U.S. Department of Energy  
**Office of River Protection**

04-WTP-268

U.S. DEPARTMENT OF ENERGY (DOE), OFFICE OF RIVER PROTECTION (ORP)  
RESPONSES TO THE DEFENSE NUCLEAR FACILITIES SAFETY BOARD (DNFSB)  
CONCERNS

## **Responses to Issues Raised in July 21, 2004 Defense Nuclear Facilities Safety Board (DNFSB) Letter Regarding Waste Treatment and Immobilization Plant (WTP) Ventilation Systems Design**

Calc No.: 24590-HLW-SOC-S15T-00009, Rev. 0C

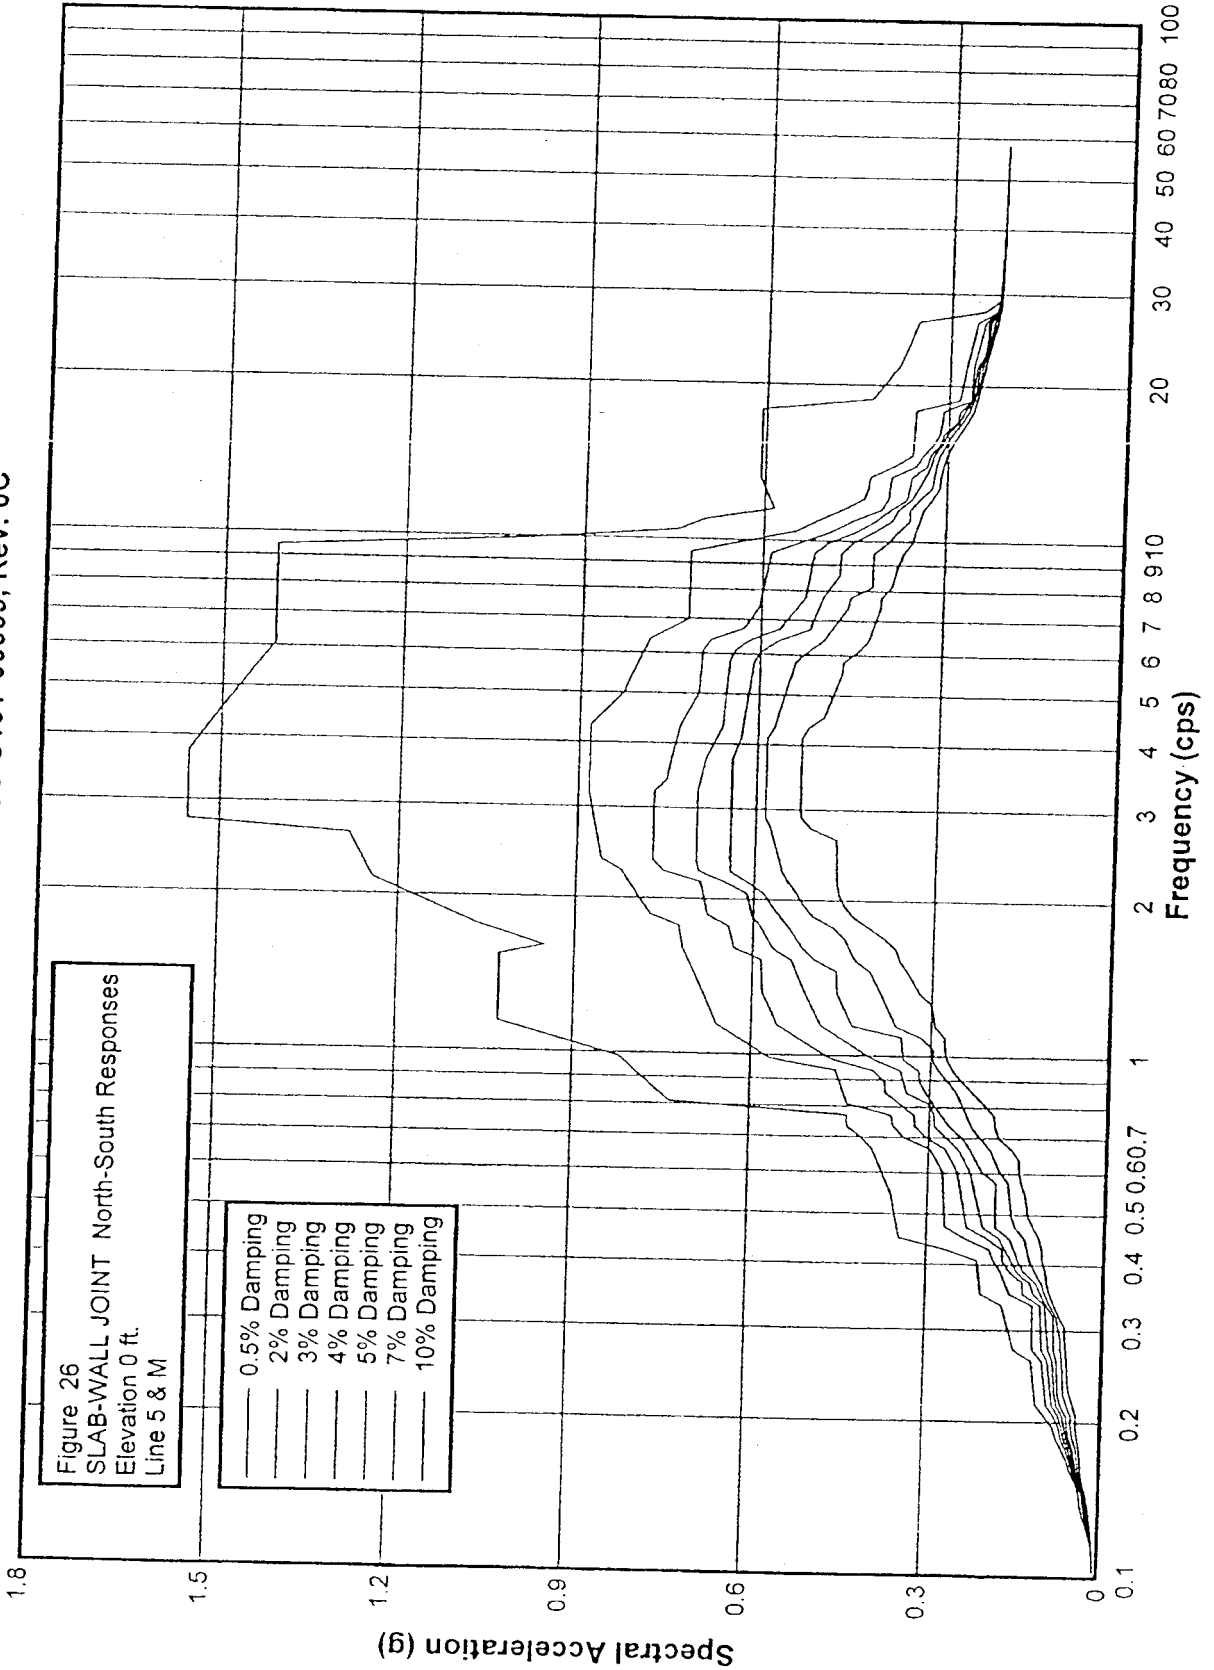
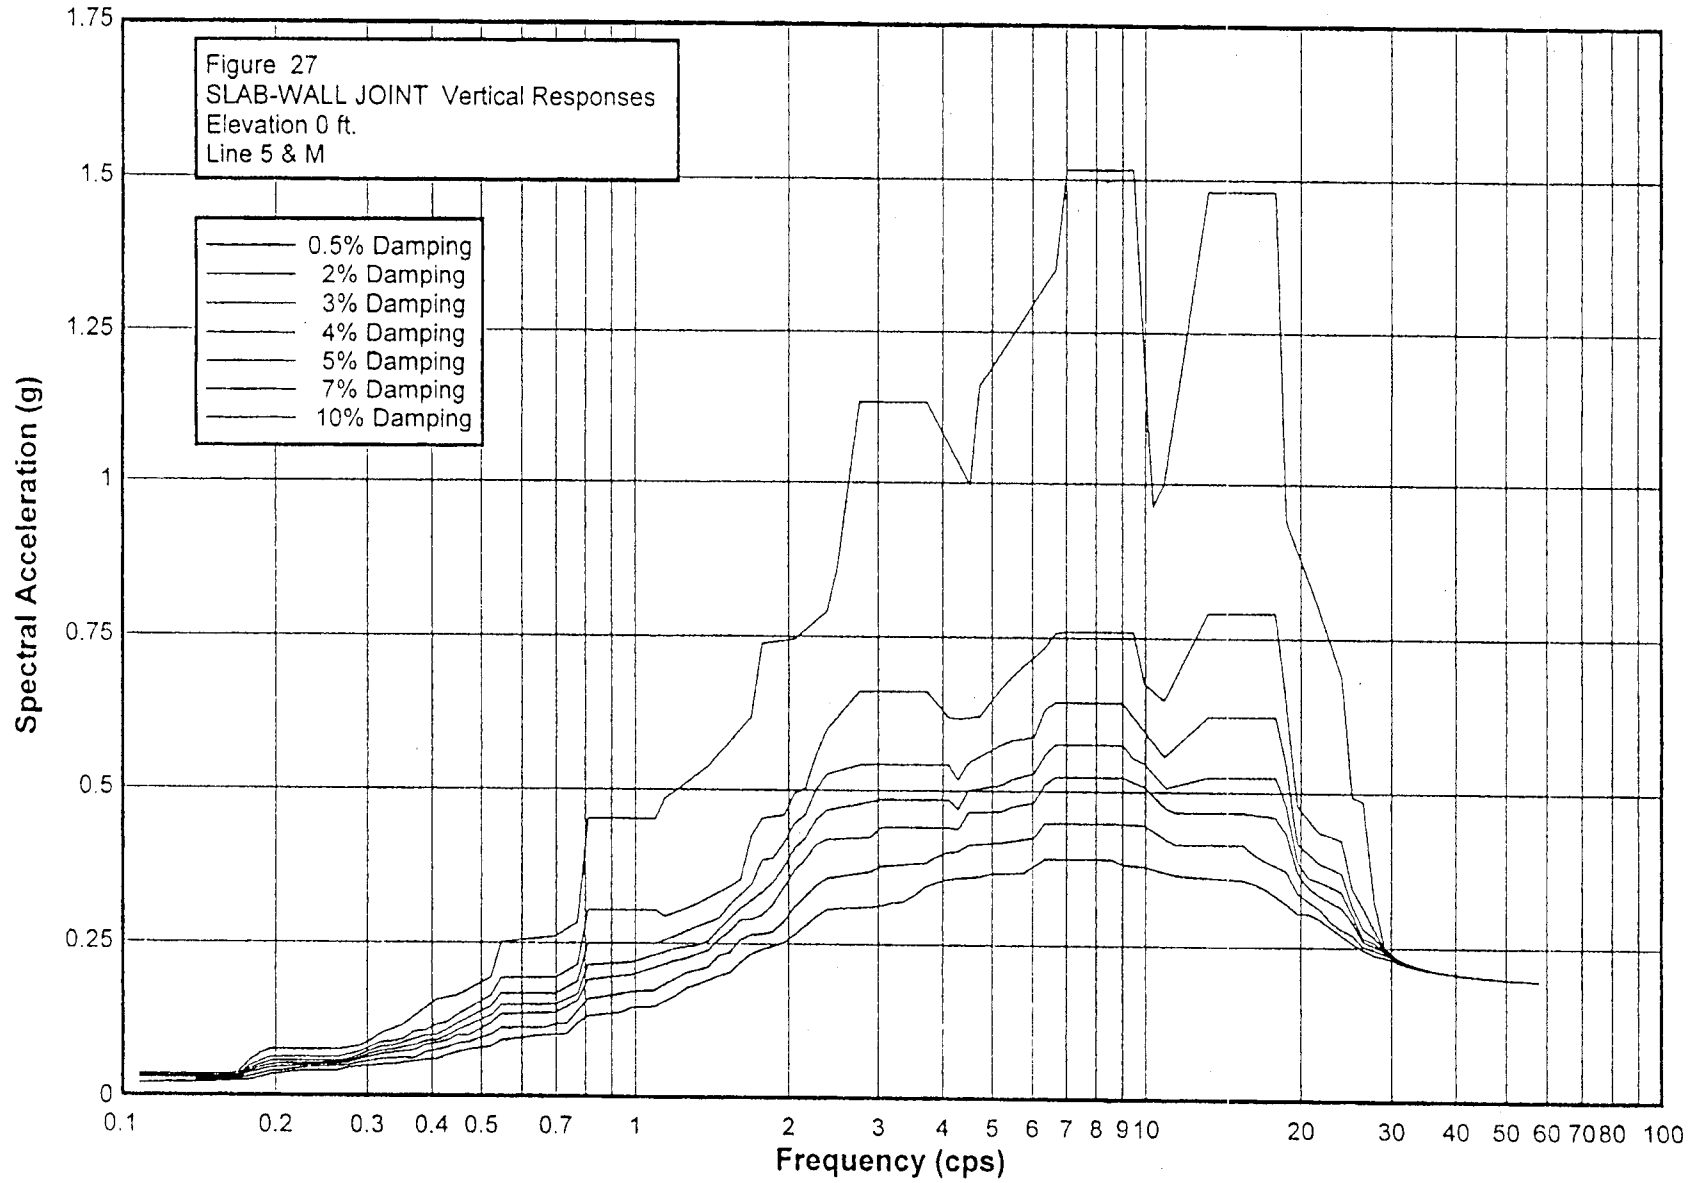
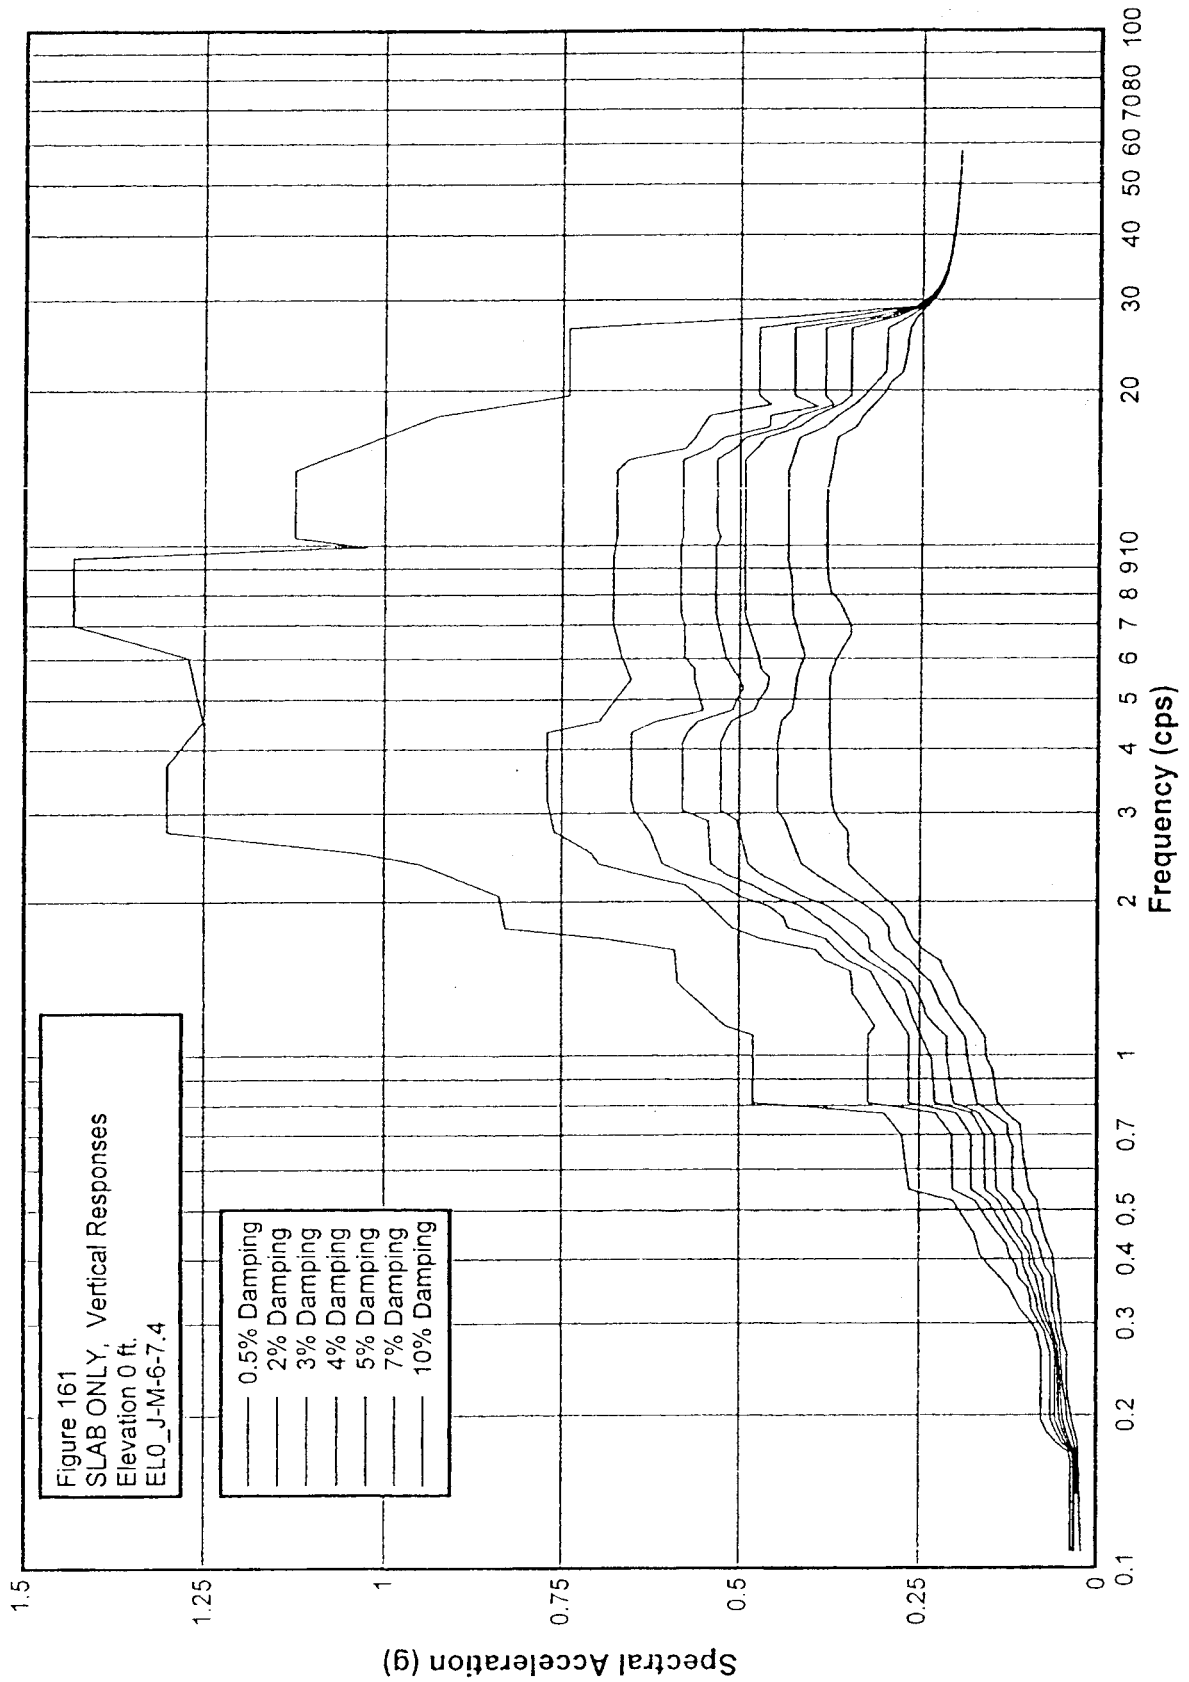
**WTP-04-281-02** The planned ventilation filter housing shaker table tests will use a bounding seismic spectra as input for the shaker table tests. The staff wants to review the bounding data for suitability.

**Response:** The WTP Project will not use bounding data for the PT and HLW facilities. The specific In-Structure Response Spectra (ISRS) curves for each facility will be used and separate testing for each facility will be conducted. The applicable curves, by elevation and column line, for the Remote Change HEPA Filter housings will be used which shows the expected frequencies and accelerations in the north/south, east/west, and vertical directions. The reason for applying the ISRS curves specific to each building and not using bounding data is as follows:

The Remote Change HEPA Filter Housings in the PT and HLW buildings will require separate testing for the following reasons:

- a) The housings are supported by steel platforms. Since the platforms are not rigid, they need to be simulated for testing. The platform configurations are different. Therefore, their simulations would be different, requiring separate testing.
- b) ISRS for PT and HLW buildings are different.
- c) It is likely that the external loads on the housings, e.g., connected ducts, in PT could be different from those in HLW.

Enclosed are the ISRS curves applicable to the Remote Change HEPA Filter housings in the HLW and PTF facilities.†
